**ADDENDUM  
NO. 3**

**October 11, 2024**

**Whiteland High School Ph 2: Café Kitchen Band Choir Auditorium**  
**300 E. Main Street**  
**Whiteland, IN 46184**

1 BAND AV ELEVATION - REAR  
3/8" = 1'-0"

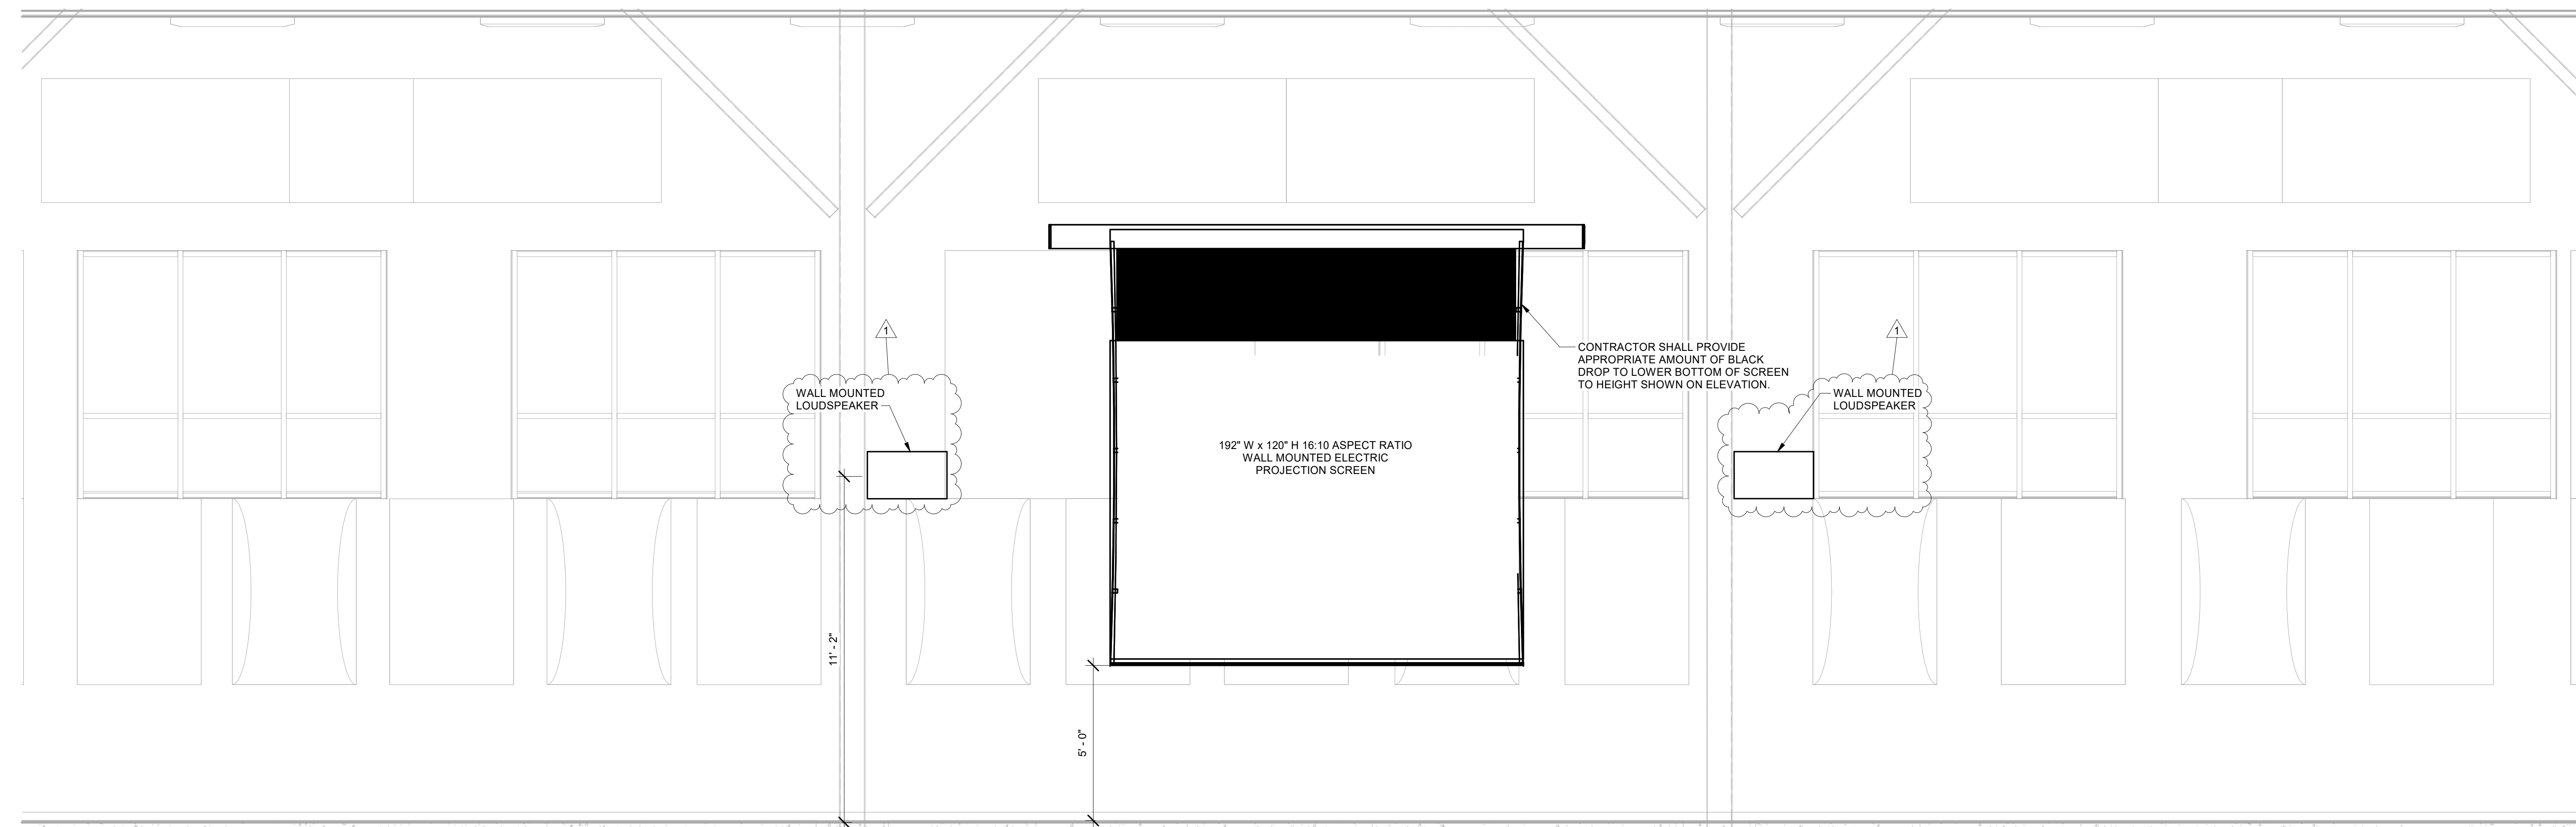
- a. AV elevations formerly placed on Sheet 317 are now placed on Sheet 318
- b. Updated rear loudspeaker annotations and mounting configuration in the Band AV Elevation - Rear to match loudspeaker specifications and dimensions

1 BAND AV ELEVATION - FRONT  
3/8" = 1'-0"

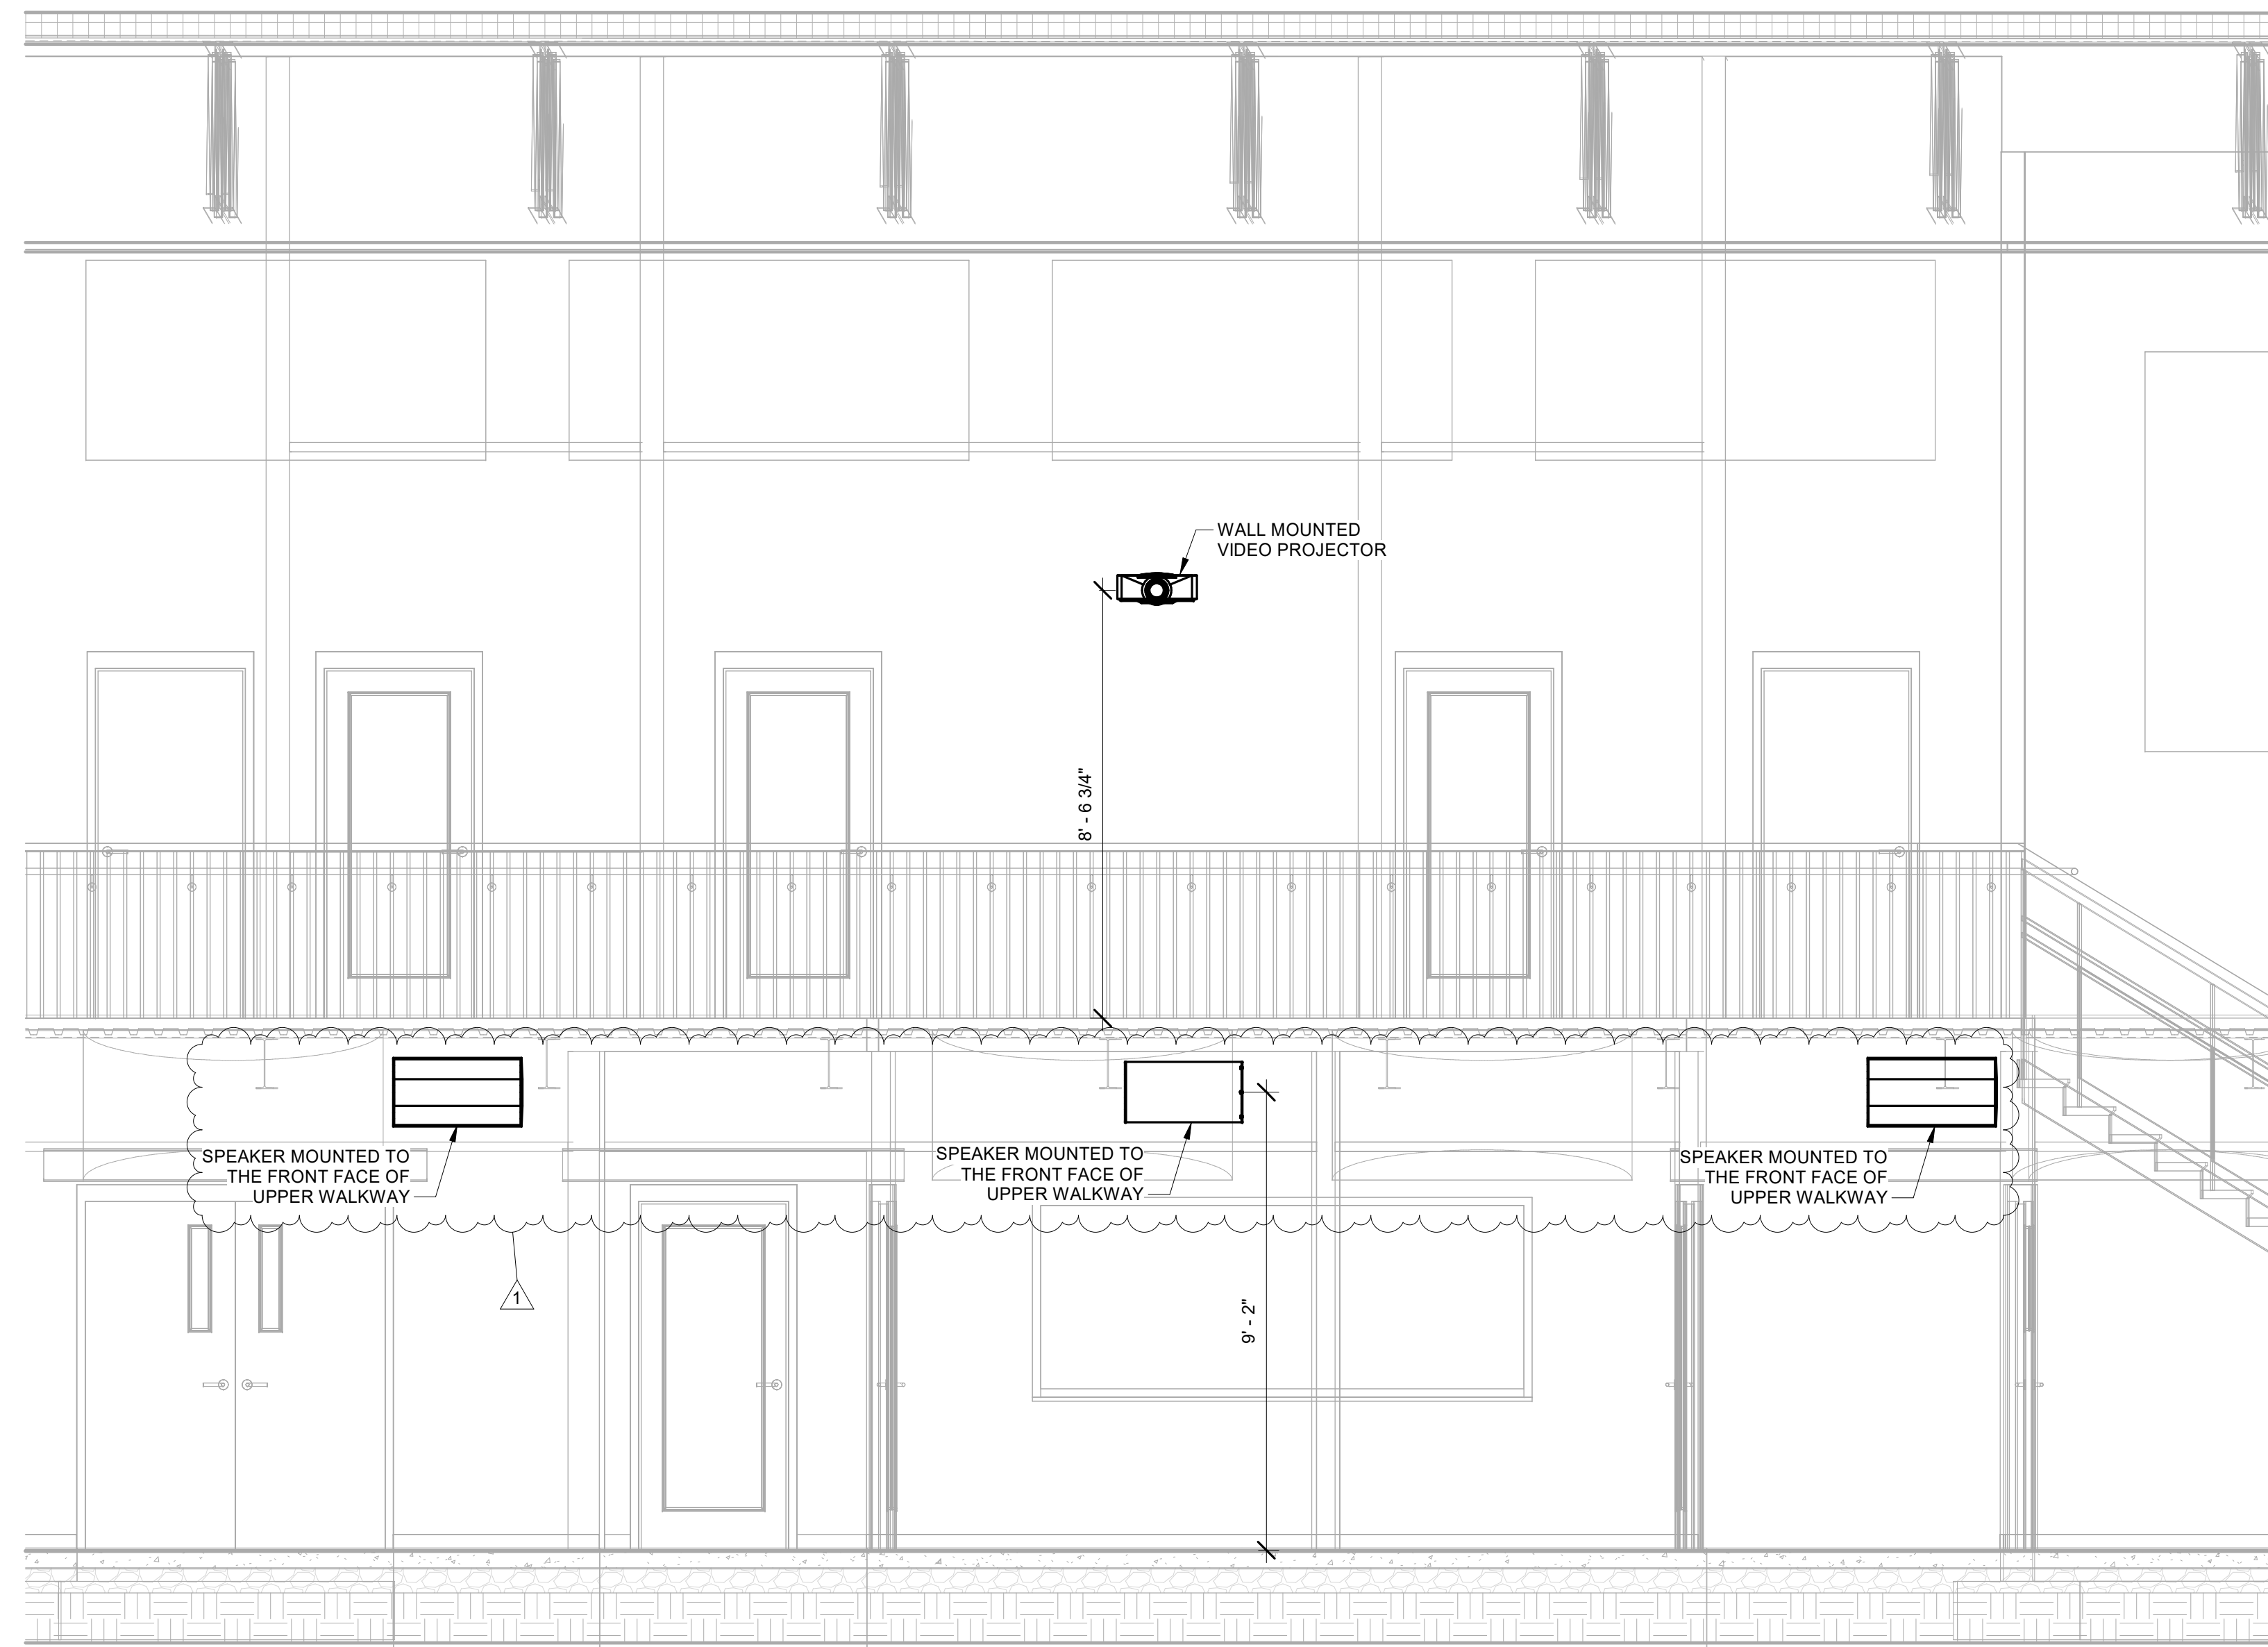
- a. AV elevations formerly placed on Sheet 318 are now placed on Sheet 319
- b. Updated front loudspeaker annotations and mounting configuration in the Band AV Elevation - Front to match loudspeaker specifications and dimensions
- c. Added an additional back box mounting location and additional mounting instructions to include the catwalk mounted video projectors to the Typical Catwalk Device Mounting Detail

2 AUDITORIUM AV ELEVATION - SIDE  
1/4" = 1'-0"

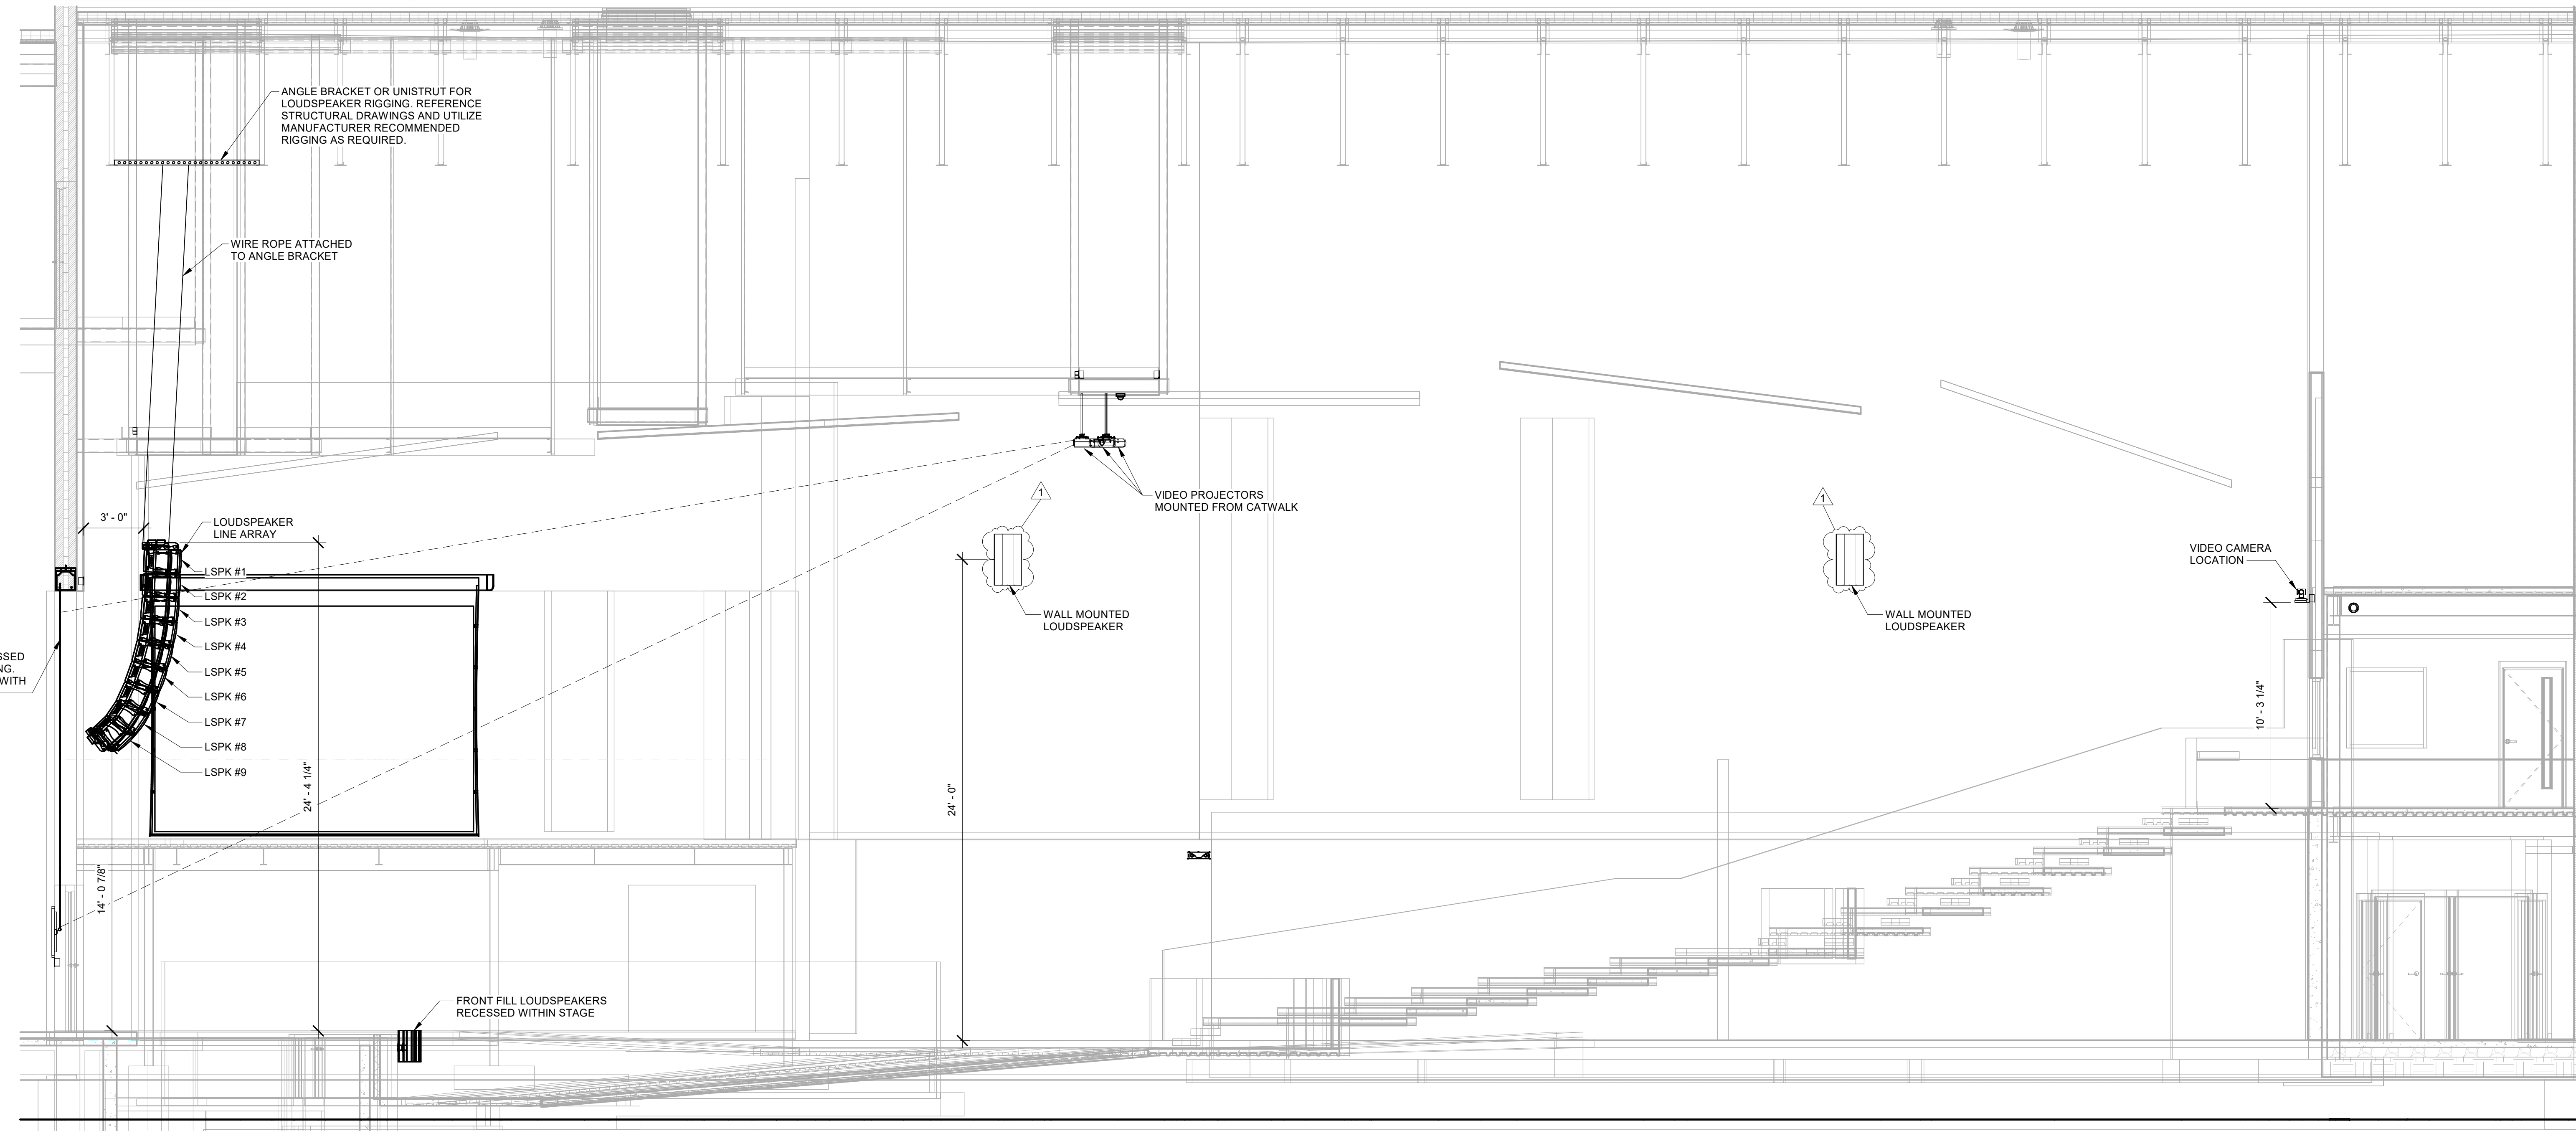
- a. AV elevations formerly placed on Sheet 319 are now placed on Sheet 320
- b. Updated the effects loudspeaker annotations and mounting configuration in the Auditorium AV Elevation – Side
